CDUA/MA-3663

With this letter, the Office of Conservation and Coastal Lands (OCCL) hereby transmits the final environmental assessment and finding of no significant impact (FEA-FONSI) for the proposed Permanent Shore Protection of the Hololani Resort Condominiums located at TMK TMK: (2) 4-3-010:009, located at Kahananui, Lahaina district, Maui for publication in the next available edition of the Environmental Notice.

**Project Name** Permanent Shore Protection of the Hololani Resort Condominiums, Kahananui, Lahaina, Maui, Hawaii

Figure 1. South end termination and schematic of end effect erosion

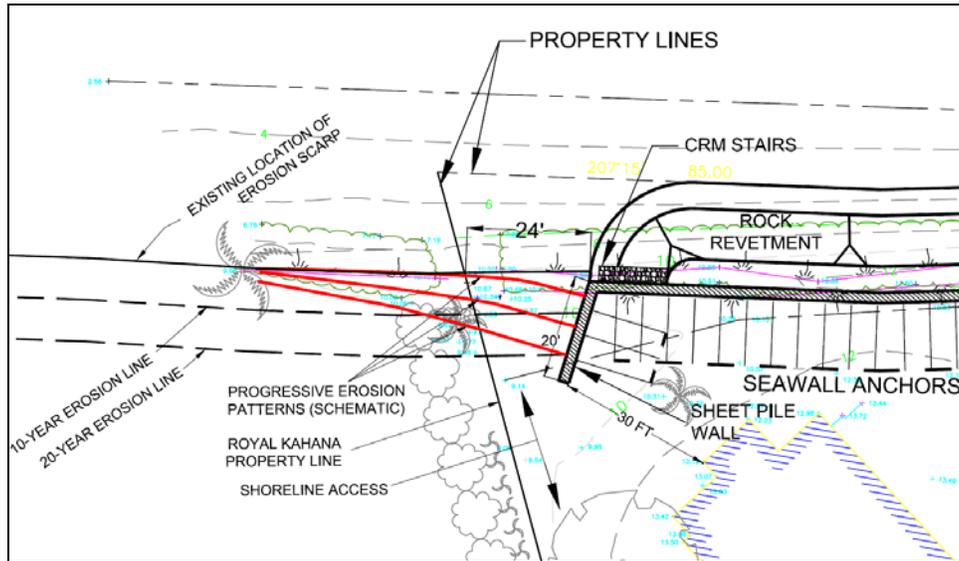
lines are based on an average of 0.8 ft per year erosion rate from a 2001 Sea Engineering study (see DEA, Section 4.1.12).
